Re: GCC Energy, LLC
King II Mine
CDRMS Permit # C-81-035
Permit Renewal 07 (RN-07)
Preliminary Adequacy Review #1 Response

This submittal is in response to your letter of May 15, 2017, "King Coal Mine, PAR for RN-07".

The Division's adequacy items are reprinted as received. GCC Energy responses are shown below each adequacy item in bold type. A replacement page schedule is attached for your convenience.

King I Mine
4424 C.R. 120
Map King I-007
Operation Plan & Surface Features

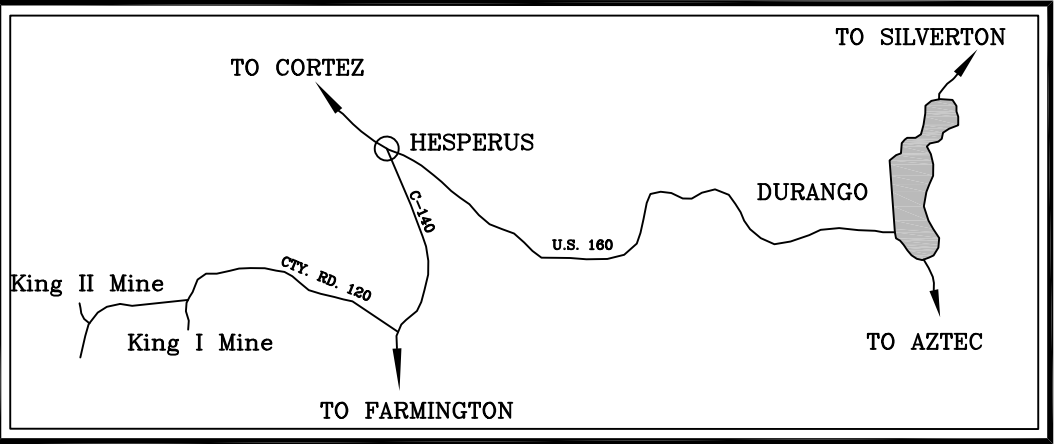
Page 3, paragraph 6: Be sure Map King I-007 is consistent with the text. If appropriate, remove the reference to the map from the text.

Page 4, paragraph 4: In the context of a topsoil borrow area, please remove the reference to Map King I-007 or update the map to show this feature.

Map King I-007 shows a waste and plant growth medium storage area between the bath house and ponds.

Update this label as appropriate. Perhaps the word “former” should be added to the label. Please explain the label “West Waste Bank (Proposed)” given that TR-20 has not been approved. Also, it would be helpful if this map (and others) indicated the source of the topography lines (e.g., aerial survey in 2015). Update the map to show the topsoil borrow area.

Text has been modified to be consistent with Map King I-007.

Page 4, paragraph 4 text has been revised to be consistent with Map King I-007.

Text has been updated, and Map King I-007 has been modified to reflect the Wiltse Well.

Map King I-007 has been modified as requested.

King II Mine
6473 C.R. 120
Map King II-001
Permit & Adjacent Areas

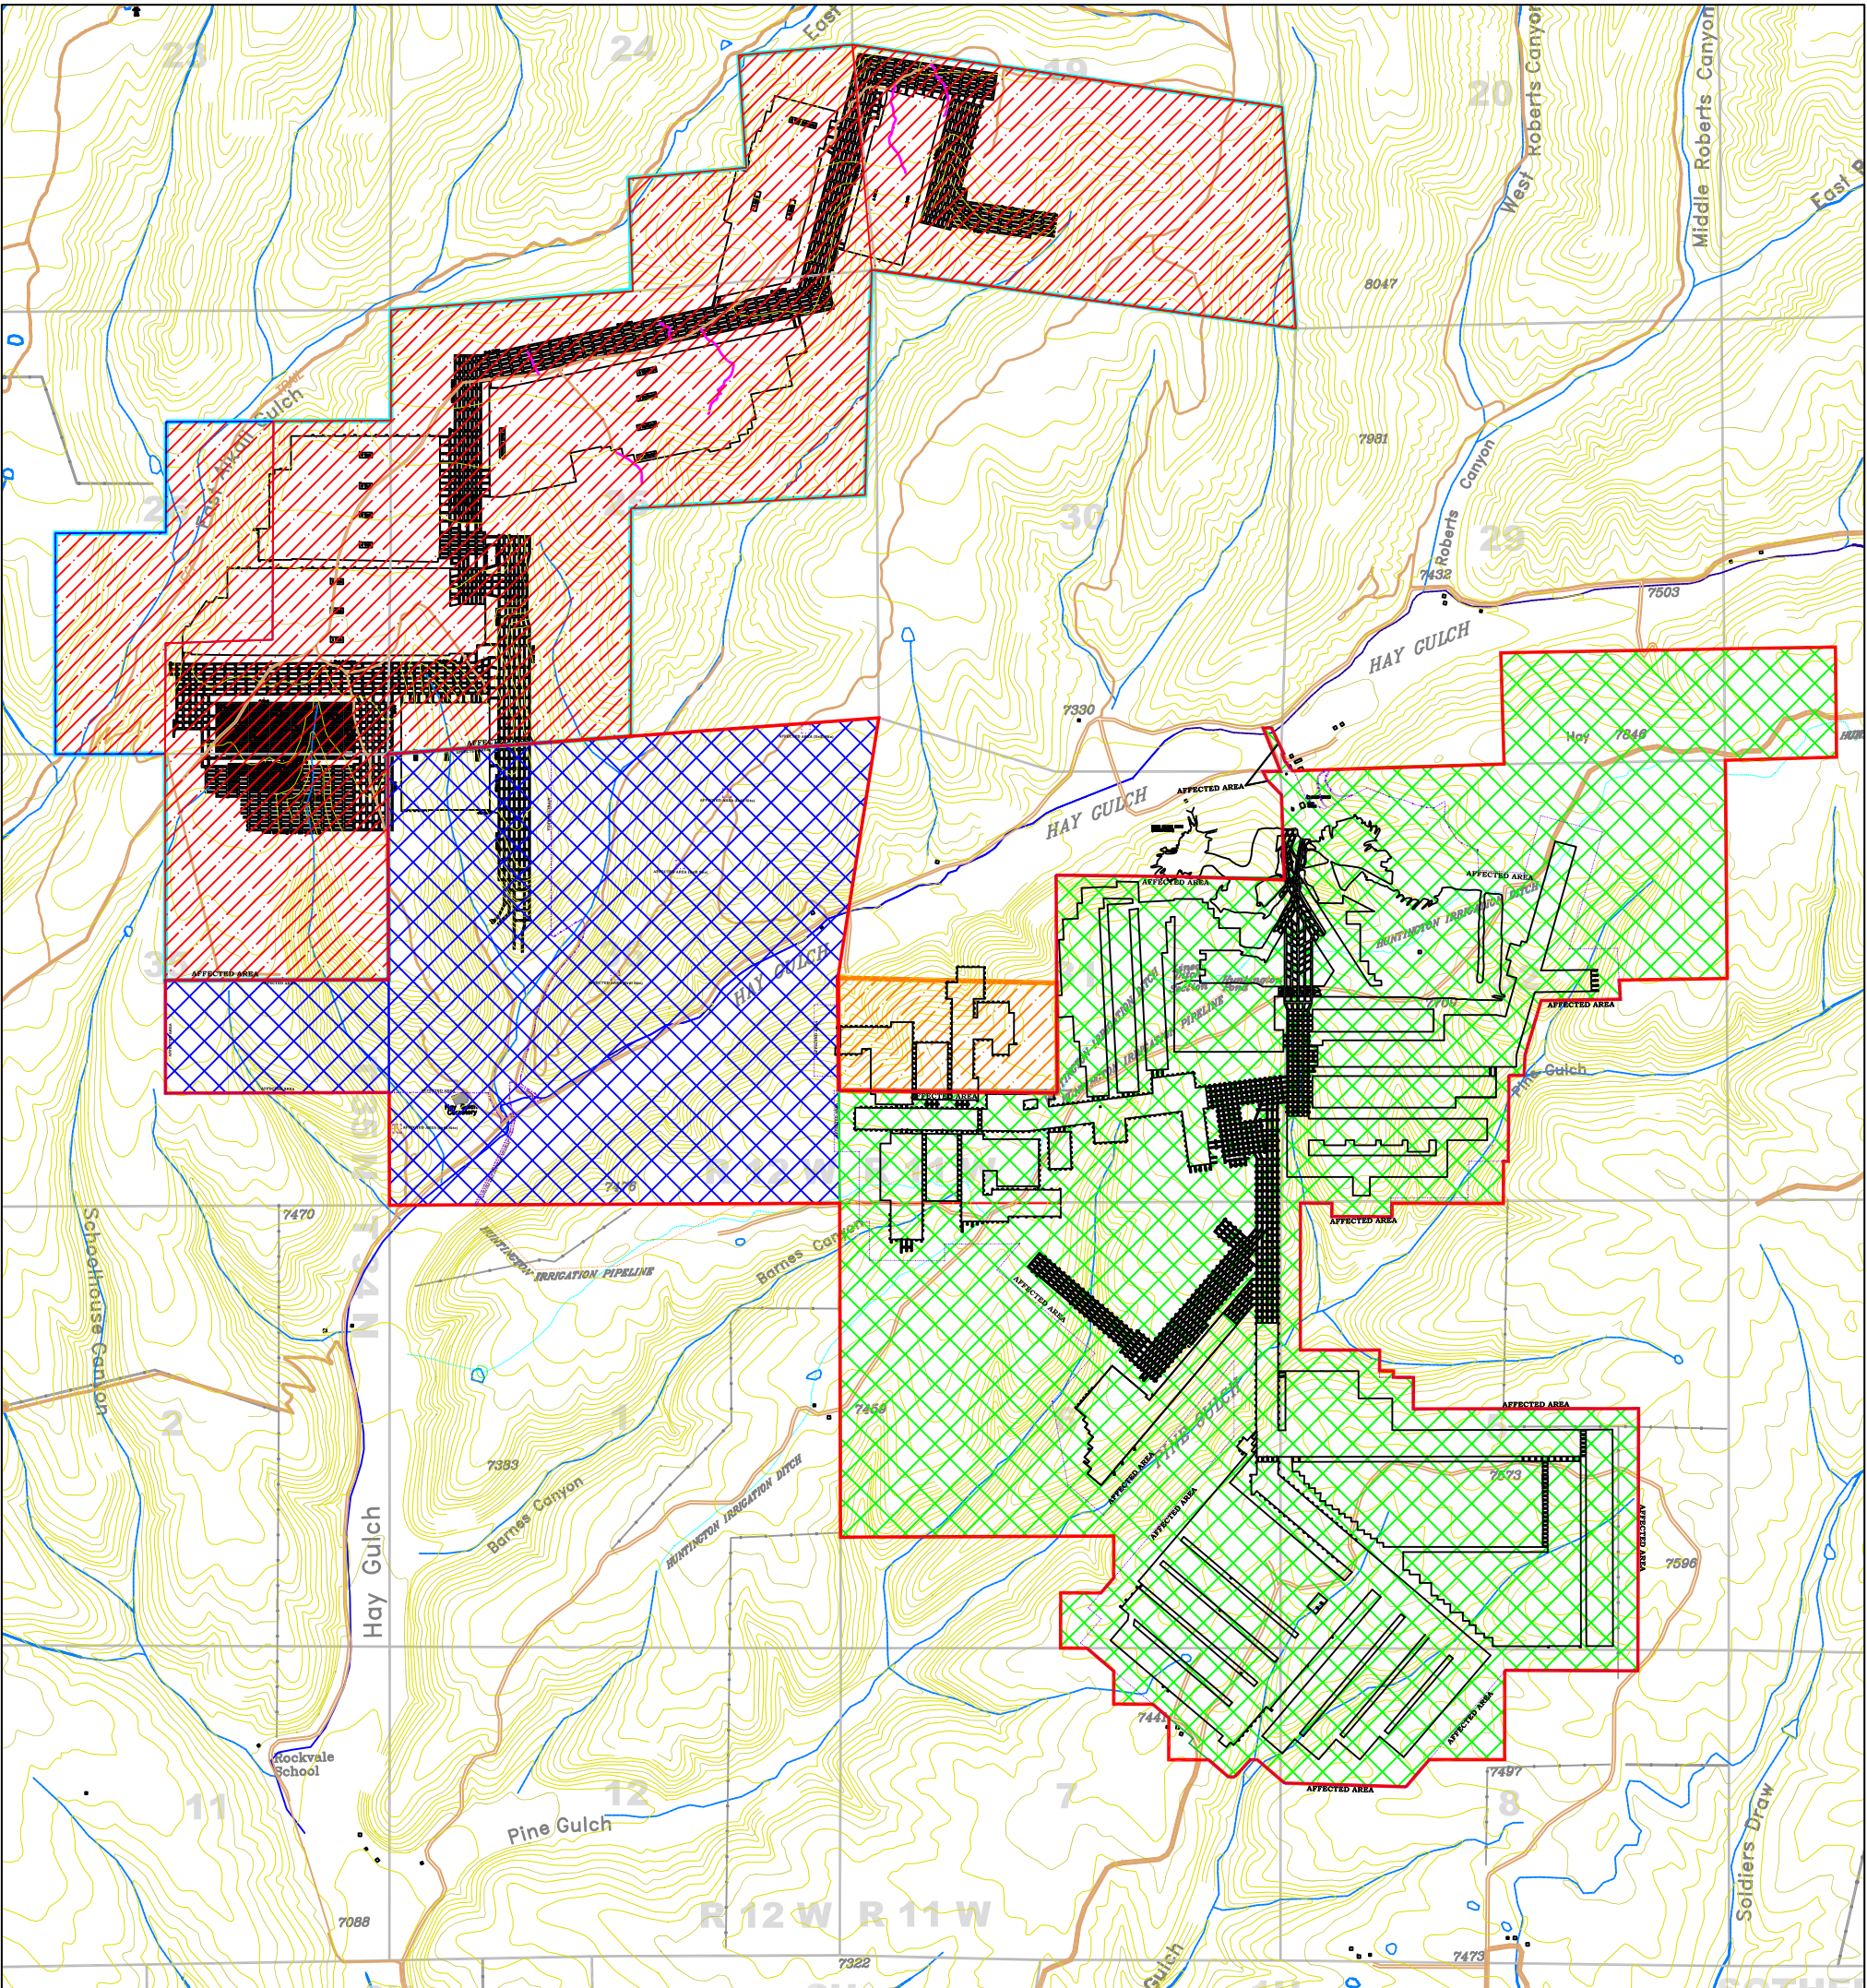
On Map King II-001, the hatching implies that the area in the northwest corner (in Section 26 of T35N, R12W) is part of both the DRMS permit and part of the OSM permit. Please explain or revise.

The hatching on Map King II-001 has been modified to clarify the division between the DRMS and OSMRE permits.
